# **8XC196KD COMMERCIAL APPLICATION SPECIFICATION UPDATE**

Release Date: July, 1996

Order Number 272833-001

The 8XC196KD Commercial may contain design defects or errors known as errata. Characterized errata that may cause the 8XC196KD Commercial's behavior to deviate from published specifications are documented in this specification update.

### **9600002. Write Cycle During Reset**

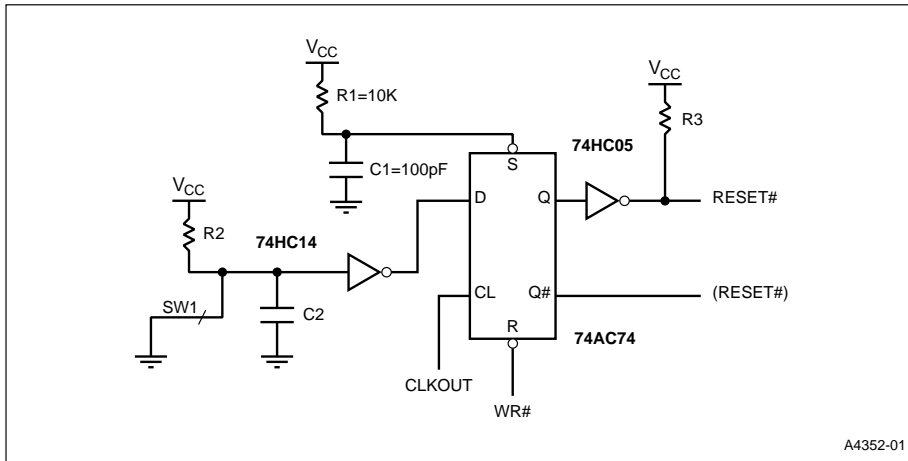
**PROBLEM:** The data bus floats asynchronously with RESET#. If reset occurs during an external write cycle, the contents of the external device may be corrupted. This is the normal operating condition for reset, and is not considered a bug. It is included on this list for those customers that may encounter corruption of data in external RAM during reset.

**IMPLICATION:** Anyone who resets a system while writing to external RAM will be affected. May have to add external circuitry if this is a problem.

**WORKAROUND:** Allow reset to occur only at the rising edge of CLKOUT and only if WR# is high. If a reset occurs during an external bus write cycle, RAM data on the external bus may be corrupted. This describes a logic design that will alleviate the problem.

The following circuit will allow a manual Reset to occur at the rising edge of CLKOUT only if WR# is high (inactive). If WR# is low (active) then RESET# will stay 'high' (inactive). The 74HC14 and 74HC05 are usually already in the system, so the only additional components are the 74AC74, R1, and C1.

1. R1 = 10K and C1 = 100 pF.
2. R2 and C2 should allow for Reset state times plus write wait states.

The  $R1 \cdot C1$  time constant is one microsecond to ensure that the flip-flop comes up 'on' after a power-up. The reset flip-flop at the rising edge of CLKOUT after the  $R2 \cdot C2$  time constant has expired.

**003. Page 8-18**

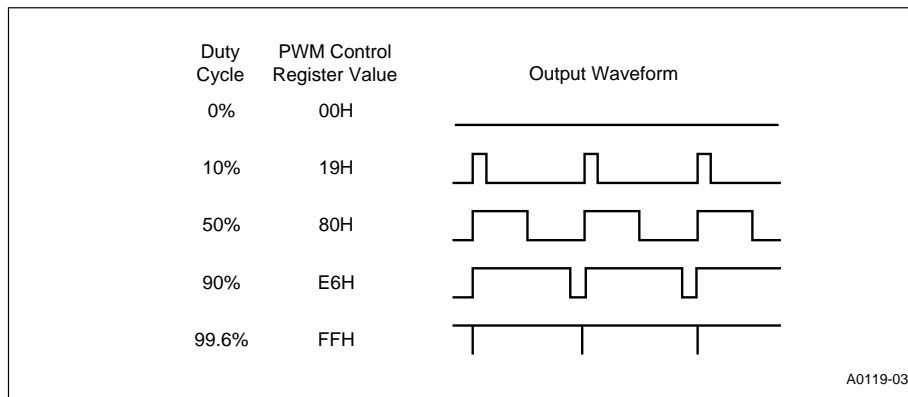
**PROBLEM:** It is explained in the second paragraph that external events generate the High-Speed Output interrupt (INT03) and internal events generate the Software Timer interrupt (INT05). An external event is defined as a toggle of one or more of the HSO outputs. An internal event is defined as the other HSO triggered events (see User's Manual). This explanation does not cover the HSO\_ALL event interrupt. By these definitions, the HSO\_ALL event would generate the High-Speed Output interrupt. Actually, the **HSO\_ALL event (Command Tag = 0Ch) generates the Software Timer interrupt**. Therefore, in the Software Timer interrupt service routine it may be necessary to see whether the HSO\_ALL event or one of the internal events (Reset Timer, Start A/D, Software Timers) caused this interrupt. The HSO event bits in the IOS2 register are set when the HSO\_ALL event occurs. Therefore, it will be easy to check if an HSO\_ALL event caused the Software Timer interrupt. This is true for the PTS vectors as well. When an HSO\_ALL event occurs, the Software Timer PTS vector location determines the PTS control block that is used.

**006. Page 11-3**

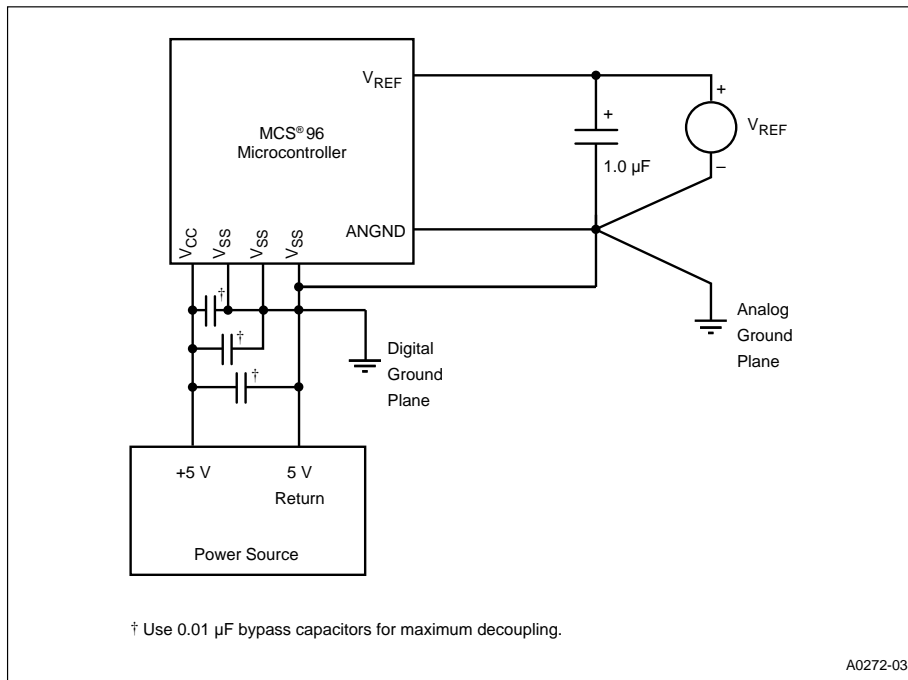
**PROBLEM:** In Figure 11-2, the recommended capacitor value between  $V_{CC}$  and  $V_{SS}$  is **0.01  $\mu\text{F}$**  or greater. Also the recommended capacitor value between  $V_{REF}$  and ANGND is **1.0  $\mu\text{F}$** .

In Section 11.2.1 the reason for these capacitors is explained. However, the second to last line of the first paragraph should read as follows:

‘Connect a 0.01- $\mu\text{F}$  bypass capacitor between  $V_{CC}$  and each  $V_{SS}$  pin and a 1.0- $\mu\text{F}$  capacitor between  $V_{REF}$  and ANGND.’

**009. Page 13-22**

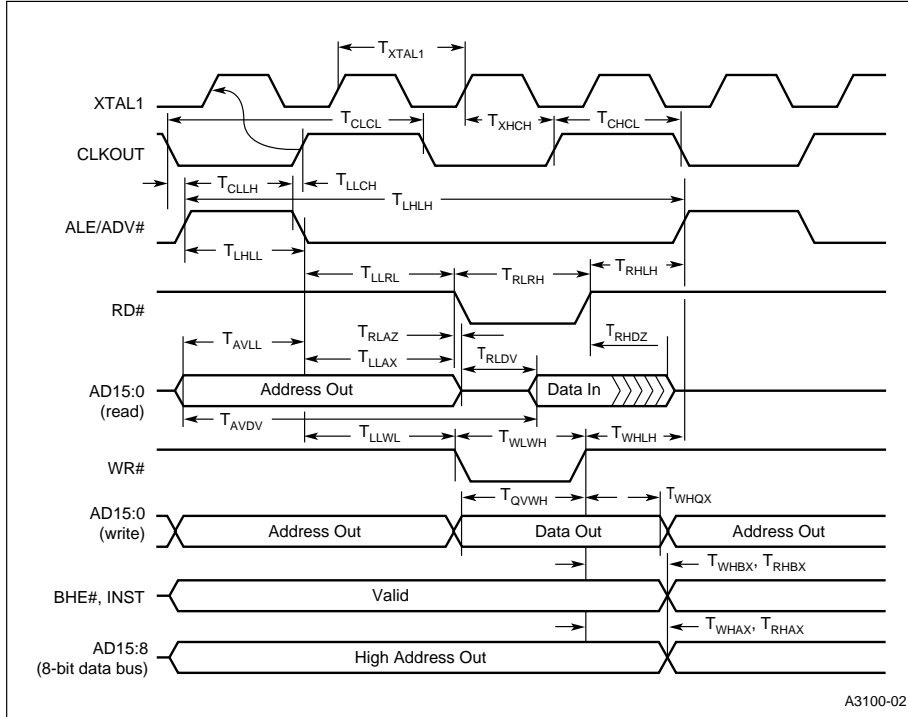
**PROBLEM:** Figure 13-20 displays the system bus timing. However, there are a couple of mistakes. First, the **WR#** signal shows a range for the transition from high to low. This is incorrect, it should be a **single line**. Next, the signal labeled **BUS** should not refer to 16-bit mode only. This BUS signal shows **AD0-7 in 8-bit mode and the entire bus (AD0-15) in 16-bit mode**. The following figure replaces Figure 13-20.

**016. Page 5-26**

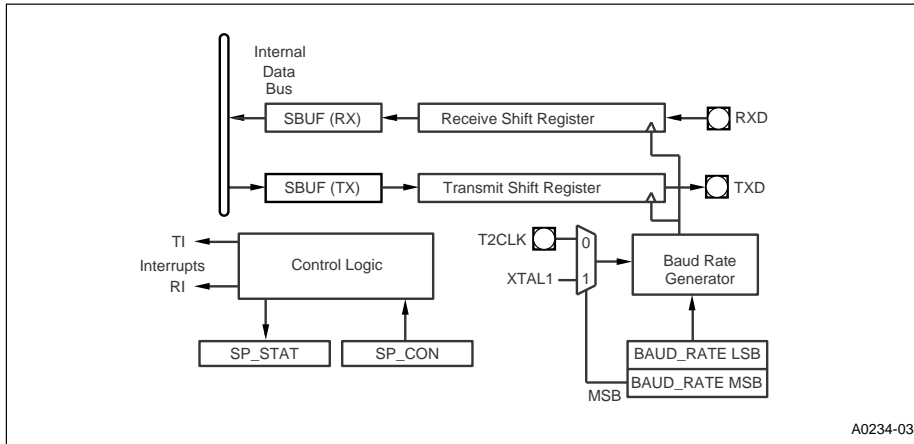
**ITEM:** In Table 5-19, the PTSCON should equal **2Ah** instead of 6Ah.

**021. Page 8-11**

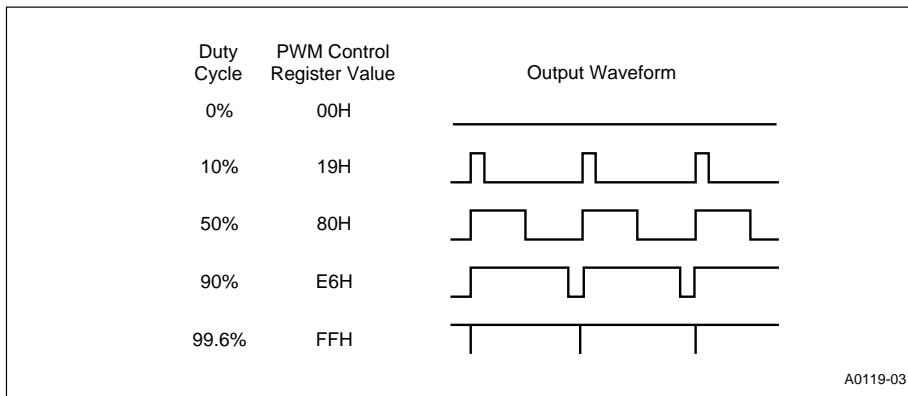
**ITEM:** The last paragraph of page 8-11 explains the operation of the divide-by-eight counter incorrectly. Replace the last paragraph with the following:

Writing to the HSI\_MODE register always resets the HSI module's divide-by-eight counter.

If you write HSI\_MODE to configure an HSI, and another HSI was previously configured for “eight positive transitions” mode, the counter reset causes the previously configured HSI to lose up to seven accumulated events. For this reason, we recommend that you use a single write to HSI\_MODE to configure all HSI inputs at once.

**026. Page 11-3**

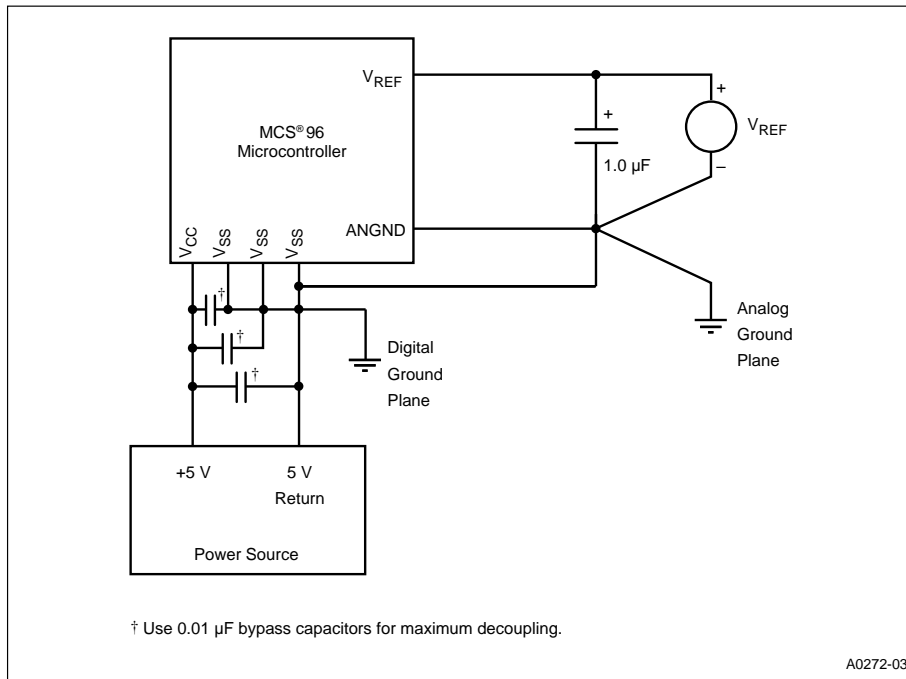
**ITEM:** In Figure 11-2, the recommended capacitor value between  $V_{CC}$  and  $V_{SS}$  is **0.01**  $\mu\text{F}$  or greater. Also the recommended capacitor value between  $V_{REF}$  and ANGND is **1.0**  $\mu\text{F}$ . The following figure replaces Figure 11-2:

In Section 11.2.1, the reason for these capacitors is explained. However, the second to last line of the first paragraph should read as follows:

‘Connect a 0.01- $\mu\text{F}$  bypass capacitor between  $V_{CC}$  and each  $V_{SS}$  pin and a 1.0- $\mu\text{F}$  capacitor between  $V_{REF}$  and ANGND.’

Figure 11-6. External Clock Drive

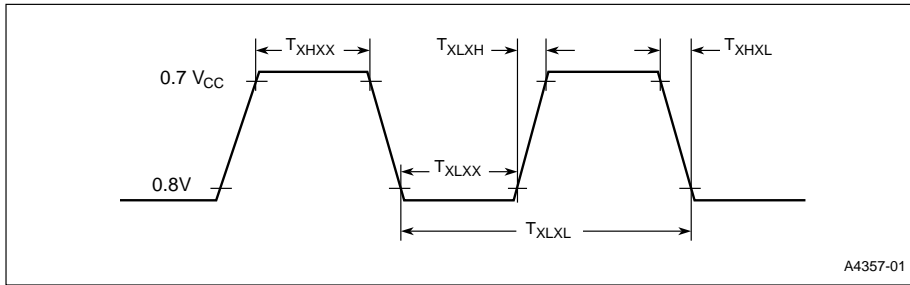
**ITEM:** In Figure 11-6, the timing diagram incorrectly represents the  $T_{xld}$  and  $T_{xhd}$  timing specifications. The timing diagram below replaces Figure 11-6.

**Figure 11-8. Reset Pin Internal Circuit**

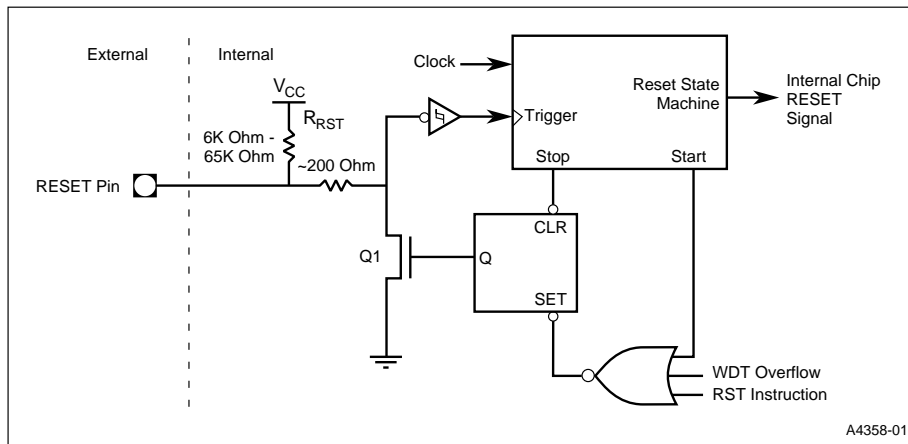
**ITEM:** Figure 11-8 shows the reset pin internal circuit. However, there are a couple of mistakes; the following figure shows the corrected version. The **inverter** at the Reset State Machines Trigger input and the **OR gate** at the SET input of the latch are the corrections to this figure.
